SECTION 00912 - ADDENDUM NUMBER 4

- 1.01 DATE: May 2, 2013
- 1.02 PROJECT: USC AIKEN GREENHOUSE
- 1.03 OSE PROJECT NUMBER H29-I337
- 1.04 GMK PROJECT NUMBER: 12036.01
- 1.05 OWNER: USC AIKEN
- 1.06 ARCHITECT: GMK Associates, Inc.

POWER RISER DIAGRAM

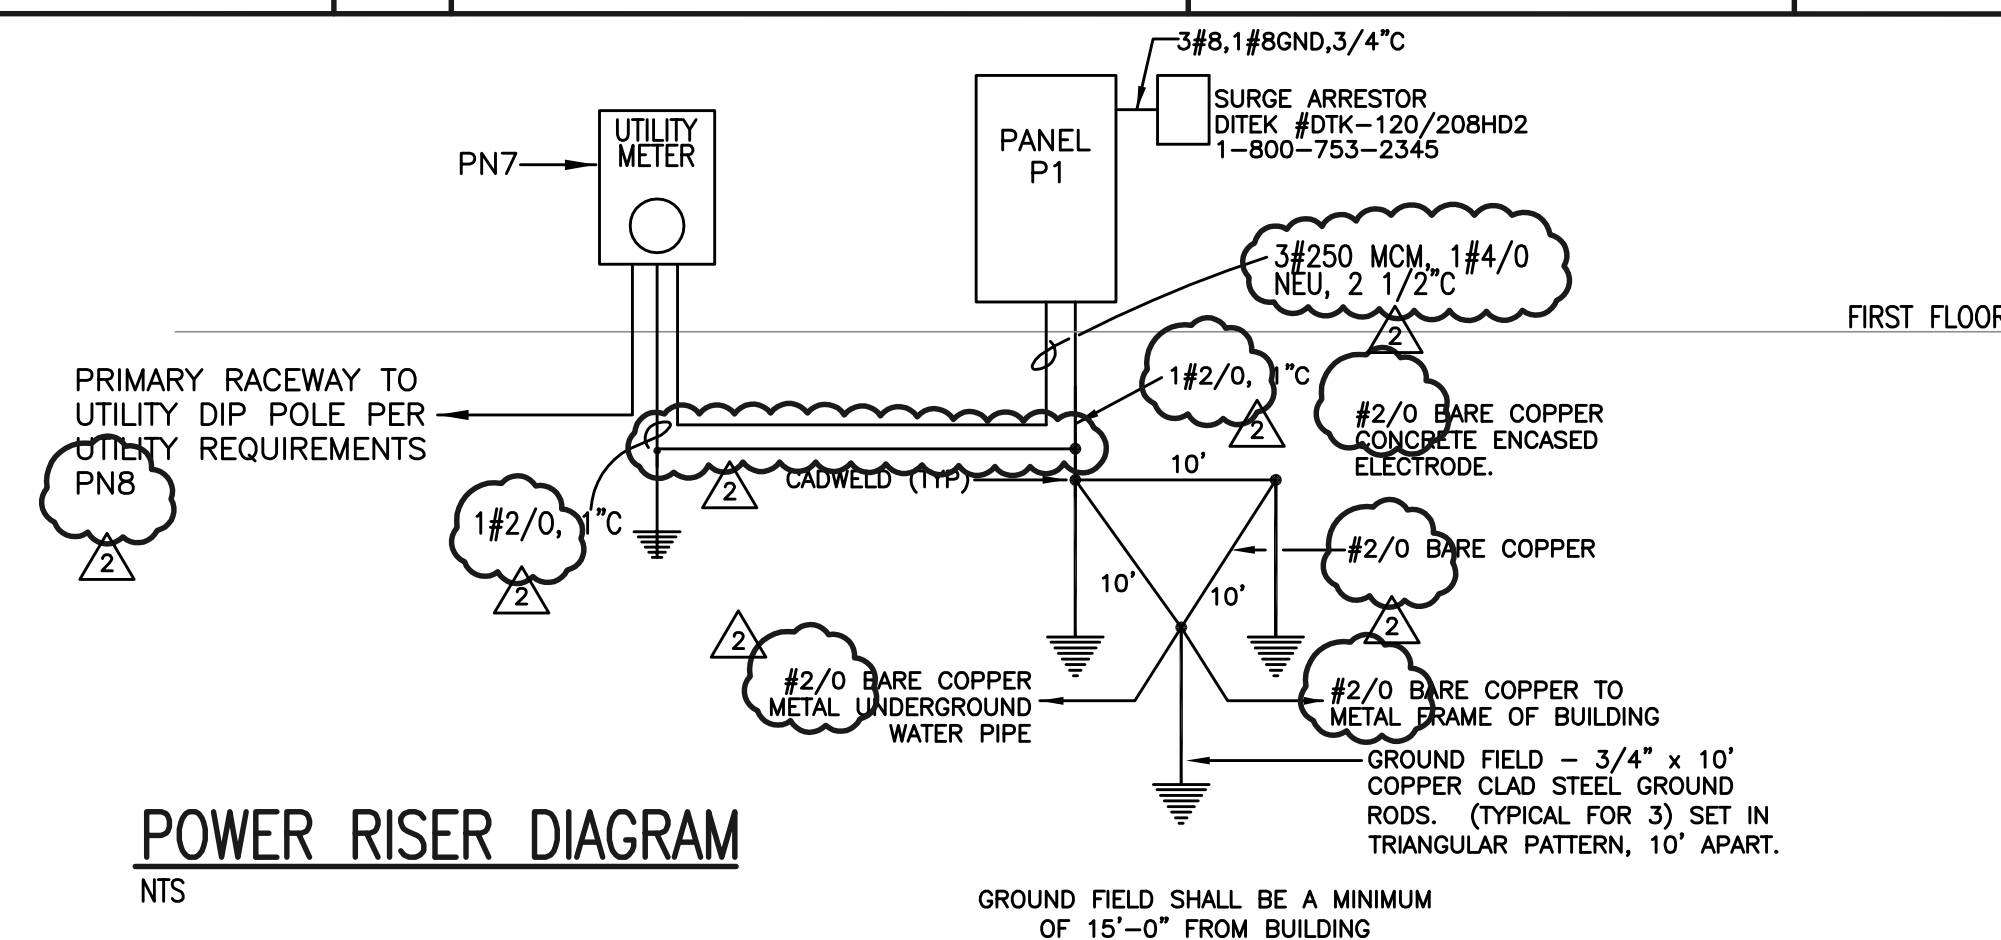
- A. Q: Need to know where the power will be feeding from (dip pole or hand hole) pipe size, wire size?
1. A: The utility company will provide temporary power to a dip pole. The contractor will provide a weatherhead on the dip pole as well as conduit fed underground from the weatherhead to the meter box. Refer to electrical drawing for size of the conduit, the feeder and the location of the dip pole.

- F. Q: At the prebid it was mentioned that the utility companies would be bringing water & gas to the building and that work is not in our contract. Sometimes the power company will only provide the wire to the meter from the DIP pole and not the raceway. Will the power company provide the raceway from the DIP pole to the meter for this job? If not then what size conduit is required and how long will it be?

1. A: The utility company will provide temporary power to a dip pole. The contractor will provide a weatherhead on the dip pole as well as conduit fed underground from the weatherhead to the meter box. Refer to electrical drawing for size of the conduit, the feeder and the location of the dip pole.
